Assessment of Dam Safety of Coal Combustion Surface Impoundments

Indianapolis Power & Light Company

Petersburg Generating Station

Draft Report

67. Pond B – South embankment crest, looking northeast.

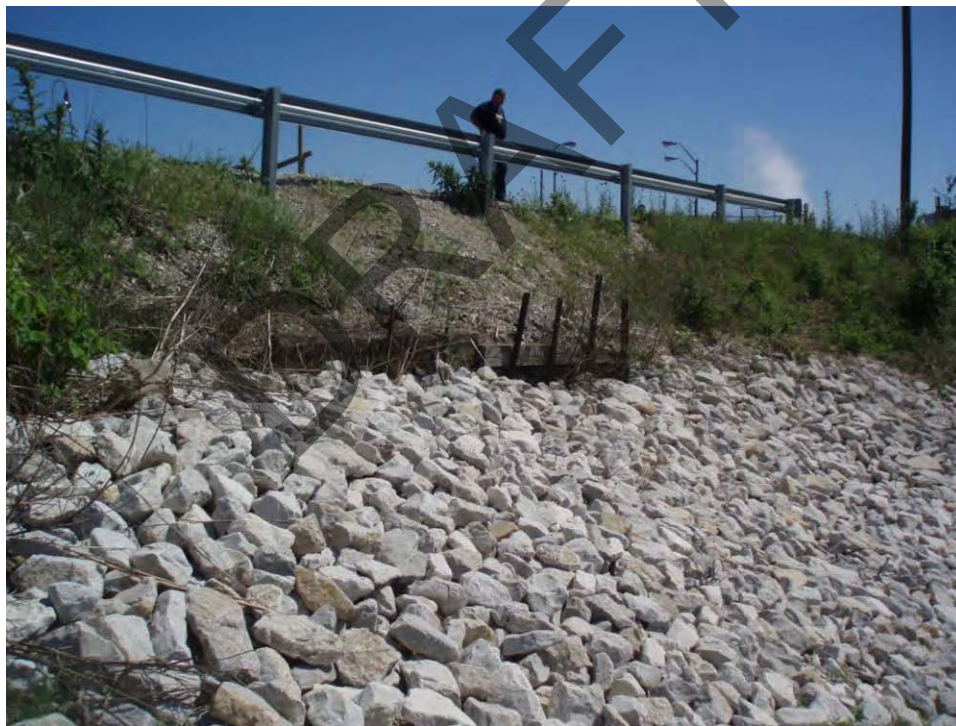
58. Pond B - South embankment exterior slope, looking west at tractor rutting and minor surficial erosion. Note change in vegetation at mid slope and stabilized FGD material very soft.

59. Pond B - South embankment exterior slope, looking west. Note change in vegetation at mid slope and stabilized FGD material is very soft.

105. Pond C - West embankment lower exterior slope, looking northeast.

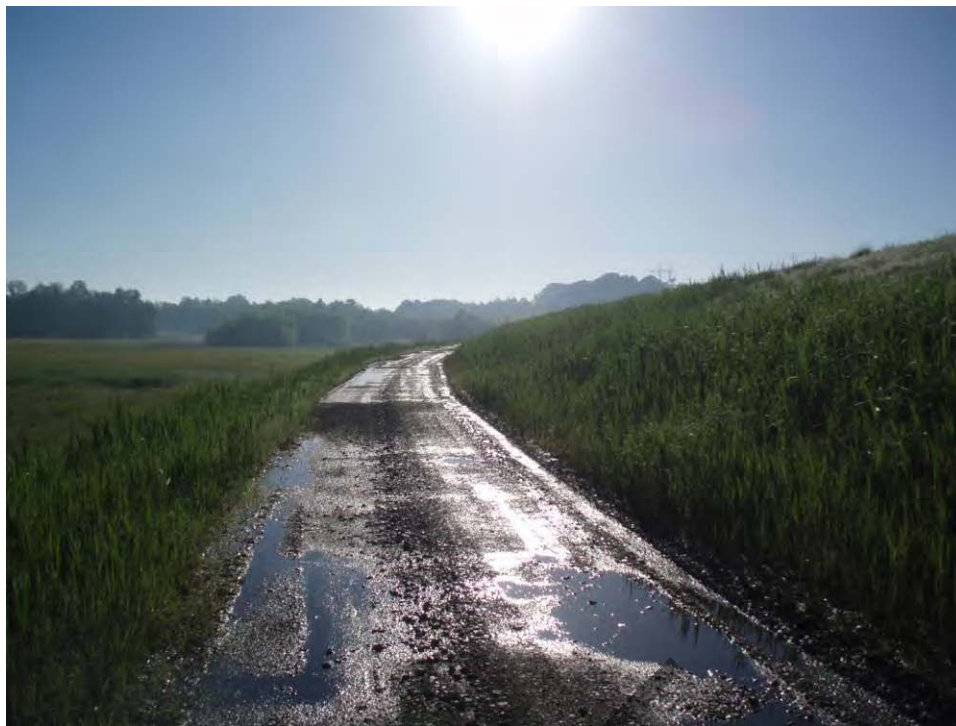
The floodplain at the toe of the west and embankment was saturated and flooded from recent storm events (Photos 105, 106, 114, and 124).

128. Pond C -East embankment crest, looking southwest. Note tire rutting was observed in very soft stabilized FGD near the crest.

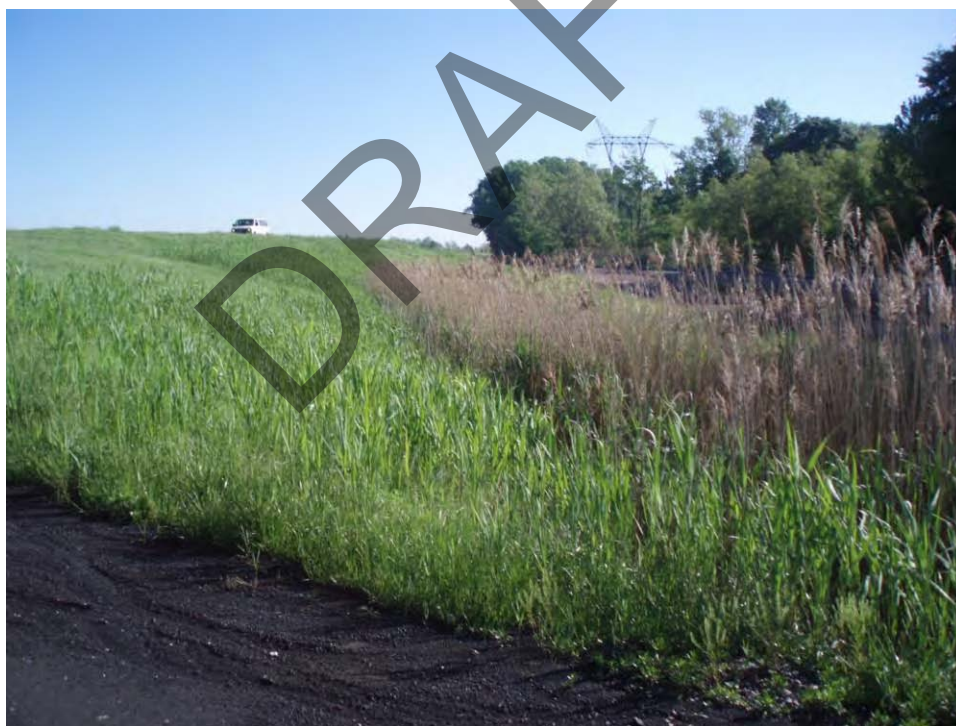
127. Pond C - East embankment exterior slope and drainage ditch, looking southwest. Note water level in drainage ditch approximately 1.5' below roadway and 5'-8' tall vegetation on lower portion of the slope extending from northern corner to access ramp. Slope at drainage ditch is over-steepened.
